SIO IT8721F-BX/DX in
Ibex Peak platform
cause S3 resume fail
issue

Technical Issue Survey Form

Prepared by: *FISH*

RD Department: *BUI/ODM1*

2)SIO PWROK connect to pin 32 PWRGD1_30ms :

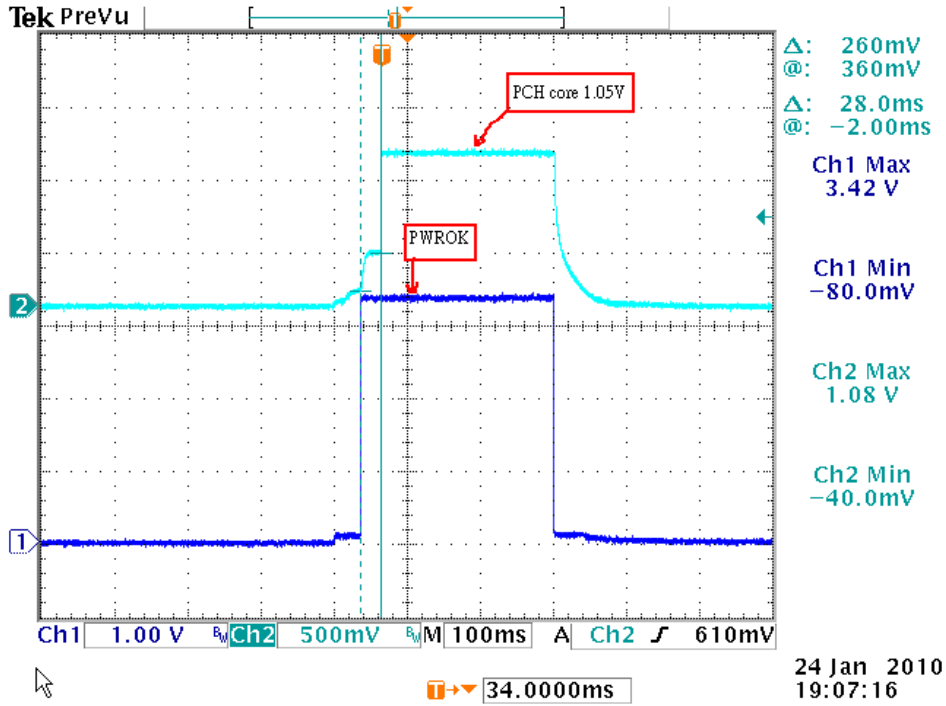
- System will power shutdown when resume from S3 state, refer to below measurement of comparison with the perspective signals PCH circuit core 1.05V and SIO PWROK in failure state:

3) Below waveform demonstrate fail state of PWROK is ready 28 ms after PCH core 1.05V active:

- Root cause : Power sequence between PCH core 1.05V and PWROK resume from S3 to S0 are failure.
- Solution : PWROK output signal changed from pin 32 PWRGD1_30ms to pin 78 PWRGD3_150ms to meet the correctly power sequence of PCH core 1.05V stable to PWROK active specification , and configure SIO PWRGD3_150ms time t5 to 135ms from register address 2A , Bit 0=1, refer to below picture:
